MILITARY SPECIFICATION SHEET

LOUDSPEAKER, PERMANENT MAGNET (ENCASED, 2-WATT, FUNGUS-, GUNBLAST-, AND IMERSSION-RESISTANT), TYPE LS-166/U

This amendment forms part of Military Specification Sheet MIL-L-12632/2A, dated 10 June 1974, and is approved by all Departments and Agencies of the Department of Defense.

FIGURE 3. Audio transformer

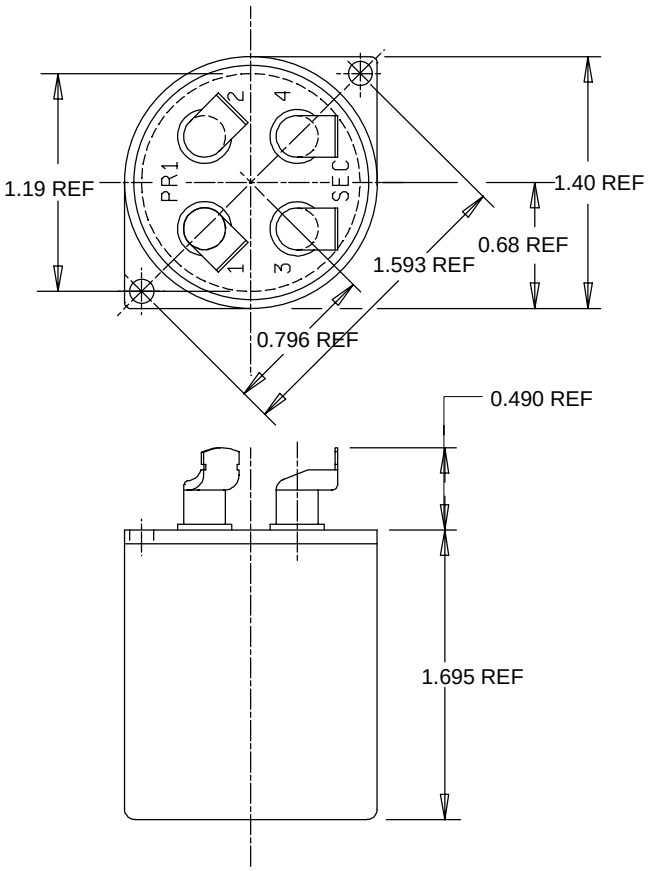
PAGE 3: FIGURE 3: Delete and substitute :

Audio transformer: Delete and substitute the following:

NOTES:
1. Dimensions are in inches and for reference only.
2. Complete dimensions and configuration characteristics are in MIL-T-27/2 for a GRADE 4, CLASS R FAMILY 21 type transformer.

"Audio transformer - Type TF4R21YY of MIL-T-27/2 (P/N M27/2-01) in accordance with MIL-T-27 (see figure 3)."
